**STAFF REPORT
ITEM NO. A.**

DATE: *October 10, 2016*

ADDRESS: *1003 McMath Ave.*

COA REQUEST: *Infill House*

Sketch of entry area

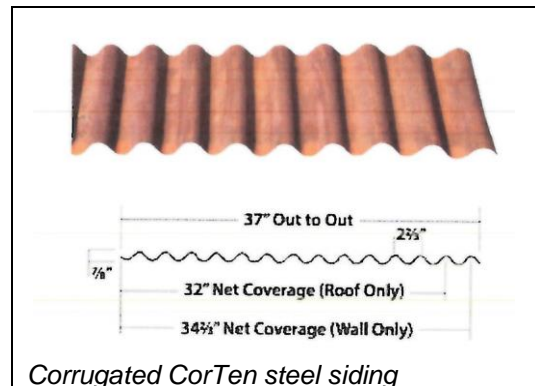
ENTRANCE AREA The entry door to the house is at the rear of the structure, not prominently displayed. This is non-typical for single family houses in the district. The dominance of the garage on the front façade is also very non-typical for the district. Staff surveyed the district and did not find any front loading garages on single family houses. The visitor entry to the house is

at the rear of the structure with few visual clues as to the location of the entry door. The entry door will feature a raised wood deck with 2x6 wood decking. This will be approximately flush with the threshold of the door. There will be no handrails or railings. There will be a small canopy over the door of CorTen standing seam roofing

Corrugated CorTen steel siding

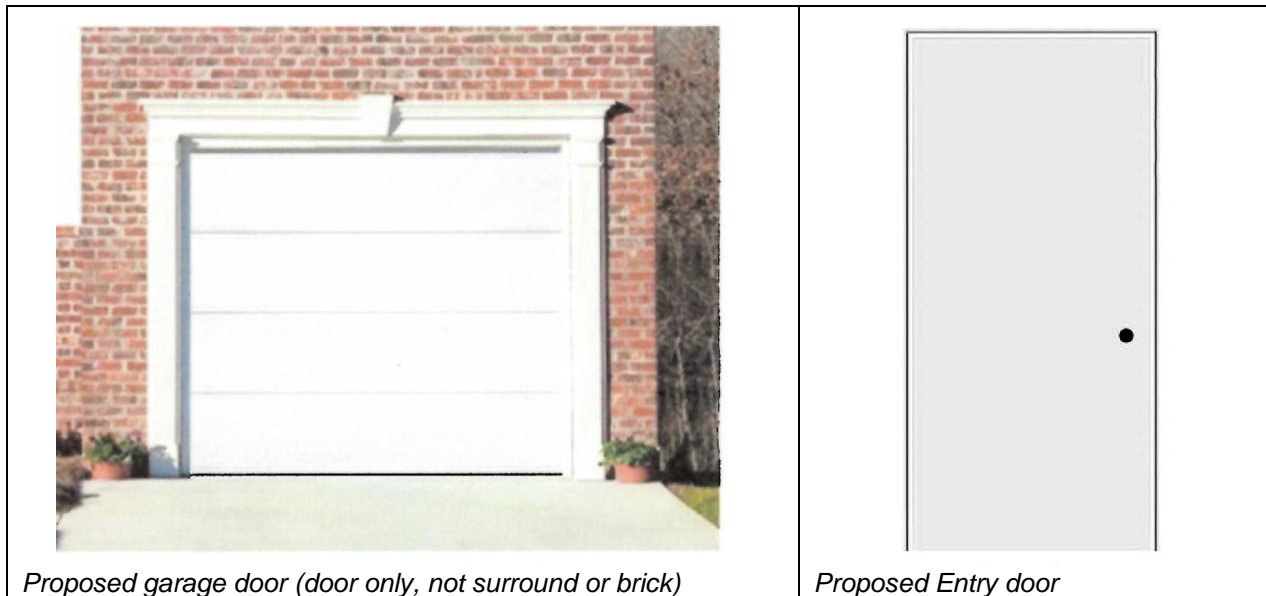
The wall areas are to be either stained white oak, brick, or CorTen corrugated steel siding in a vertical orientation. Wood siding is a common material in the district. Corrugated metal siding on a wall surface is found on accessory buildings in the district. Half of 1005 and more than half of 1003 is proposed to be built out of a material that is found on accessory structures on a non-dominant façade.

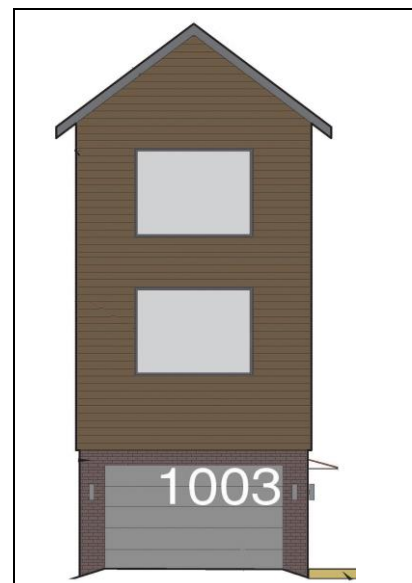
MASSING The massing of this building is taller in proportion than the rest of the buildings in the immediate area. The overall mass may be similar, but the overtly vertical nature of it does not blend with the neighborhood.

If the two houses were joined by some architectural feature to emphasize the pedestrian visitor entry, the two houses might be read as one and the proportion of the width to height would be closer to a 1:1.
